AGENDA ITEM 7
PLANNING & DEVELOPMENT SERVICE
PLANNING DIVISION
455 Mountain Village Blvd.
Mountain Village, CO 81435
(970) 728-1392

RE: Staff Memo – Final Architecture Review (FAR) Lot 649R-11, 11 Boulders Way

APPLICATION OVERVIEW: New Single-Family Home on Lot 649R-11

Agenda Item #8
PLANNING AND DEVELOPMENT SERVICES
DEPARTMENT

C2.1

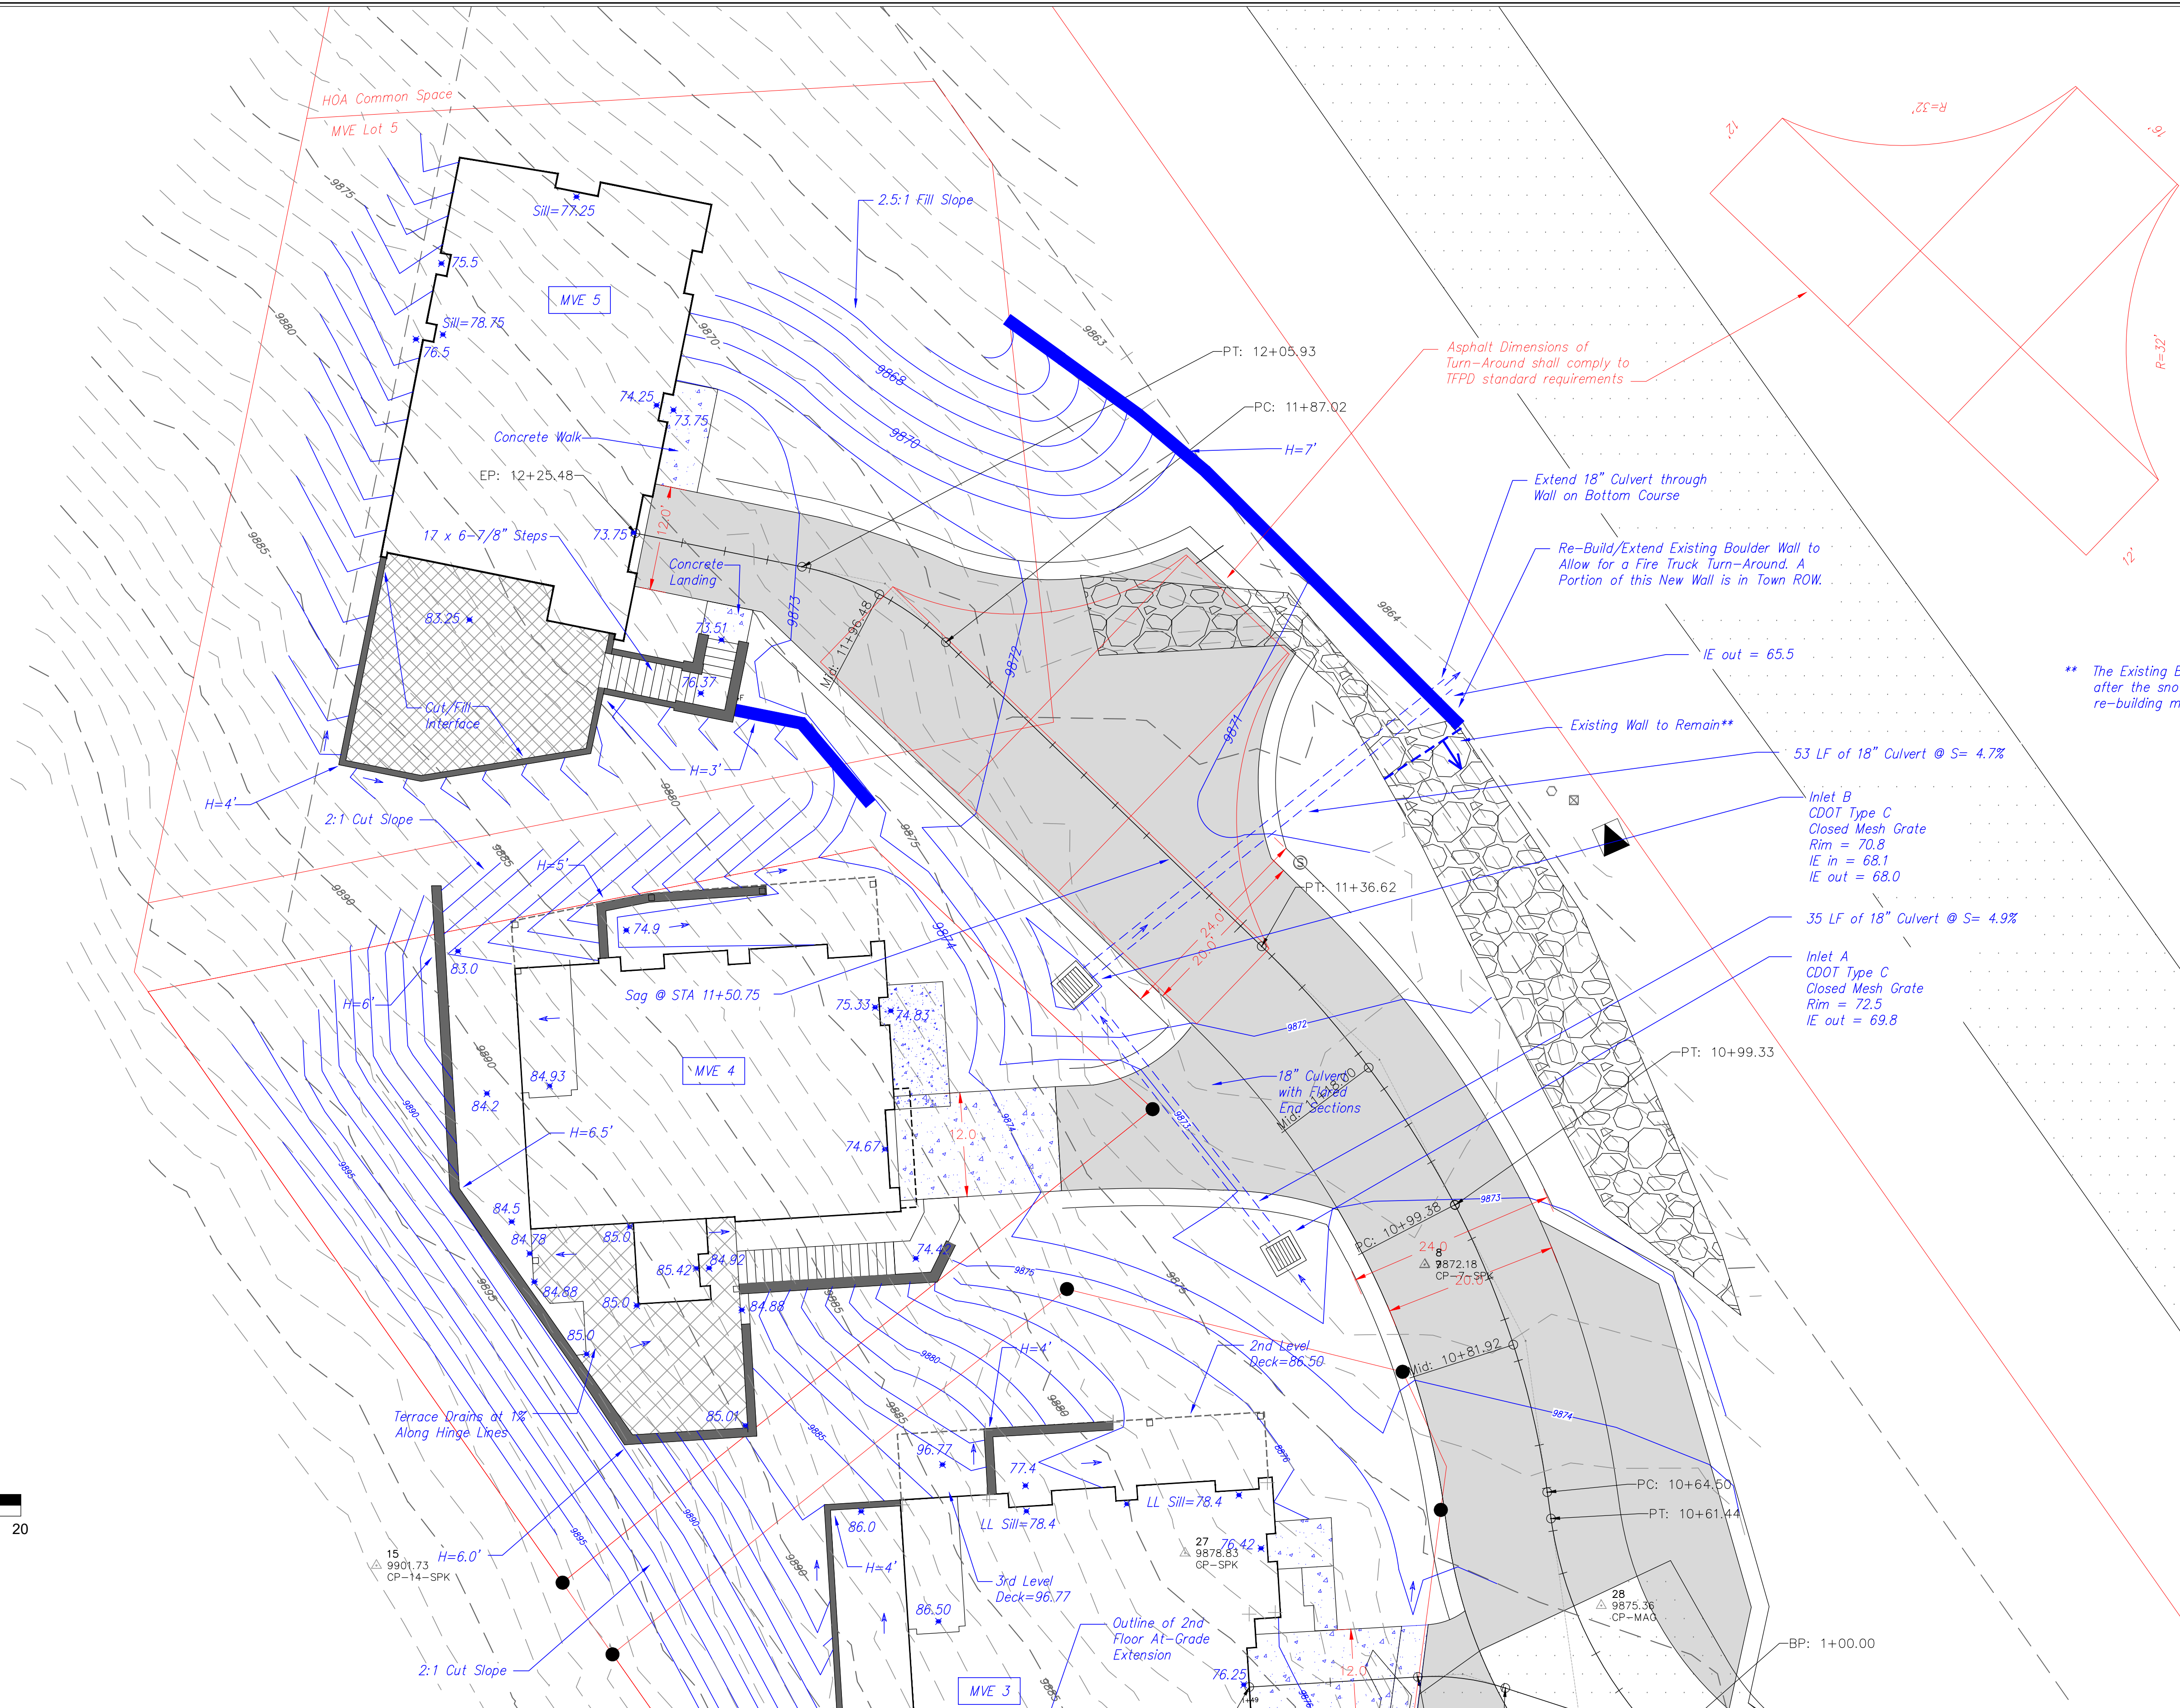
Staff: The grading and drainage plan essentially allows for the creation of the driveway. The west side of the home has some grading as well to create drainage away from the building. No slopes are proposed over 2:1, there are some extensive retaining structures along the drive with the longest stepped wall along the south side of the driveway over the allowable height of 5' at 6' and 8'. This will require a design variation to the road and driveway standards.

At Initial Review there were some concerns regarding the carriage house roof being too close to grade. The civil plans have been revised to show an extension of the retaining wall along the driveway so that it now wraps around the SW corner of the building, pulling grade away from that corner. This does increase the amount of encroachment within the GE.

C3

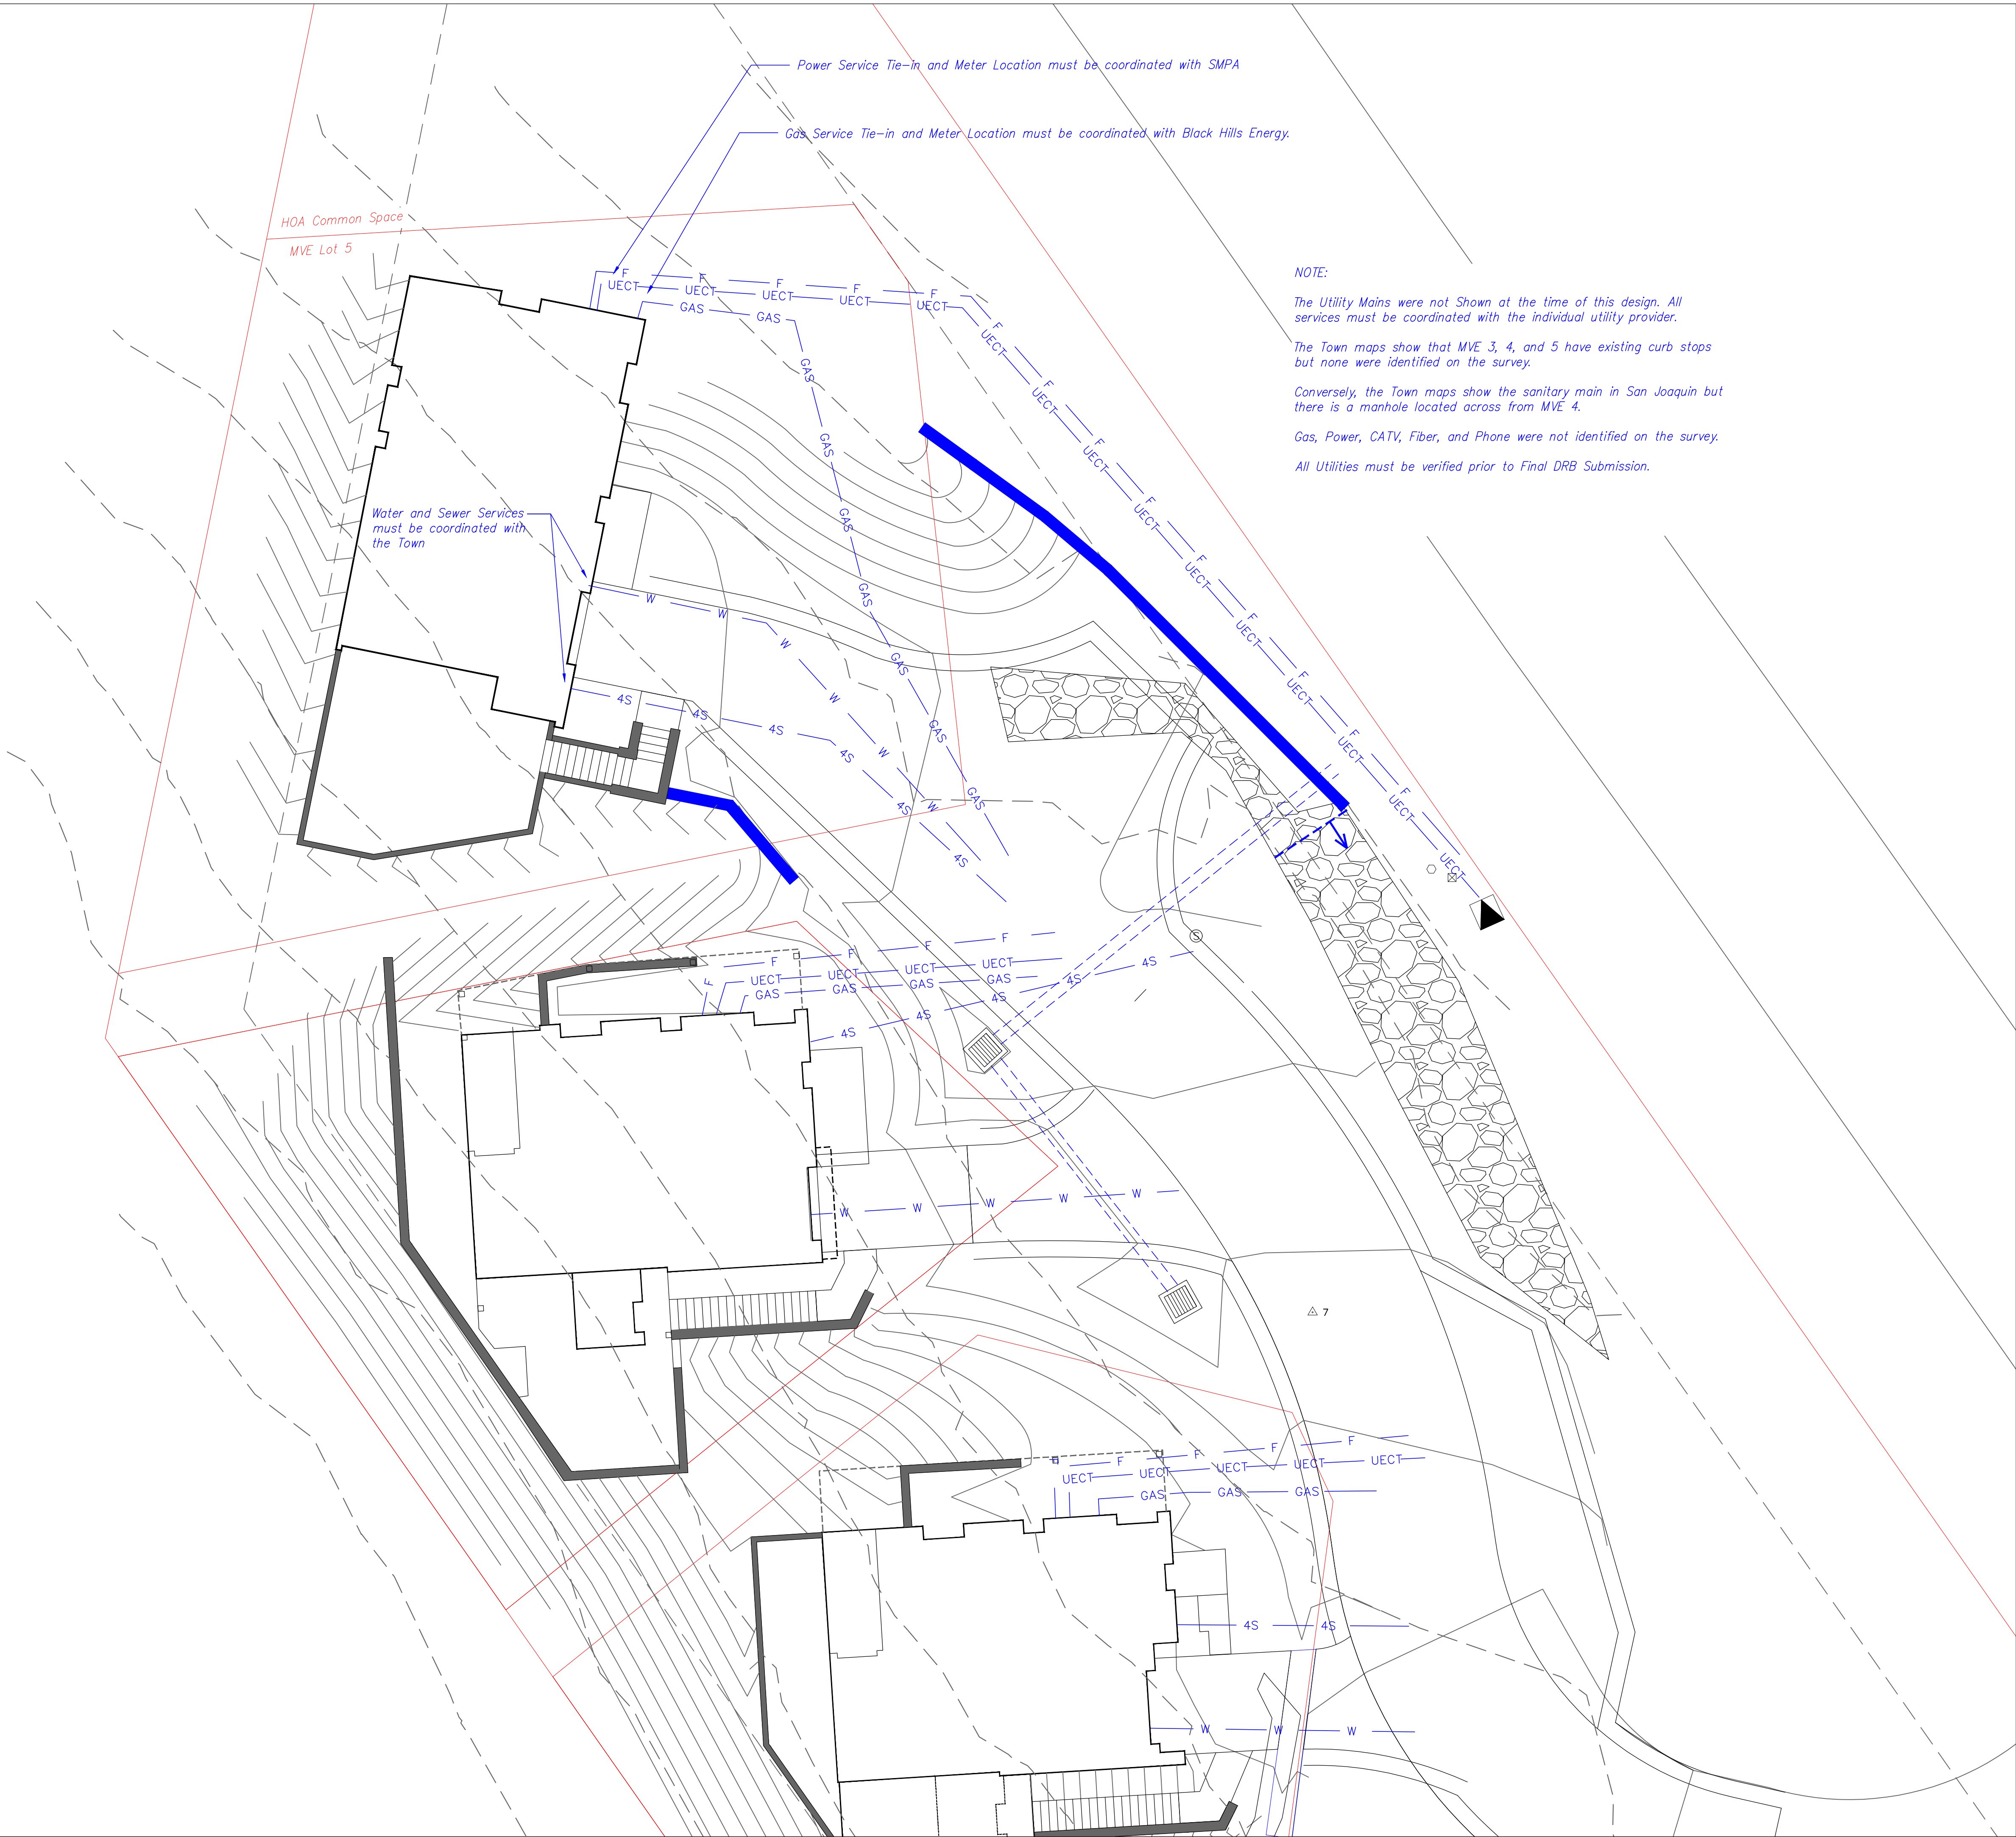
Staff: Sewer and electric run along the SE corner of one of the wetland areas. Although the construction mitigation plan shows a 15' buffer of non-disturbed area beyond the wetland, the utility plan seems to put those two utilities in this area. Staff would like to see a revised utility plan maintaining this 15' buffer.
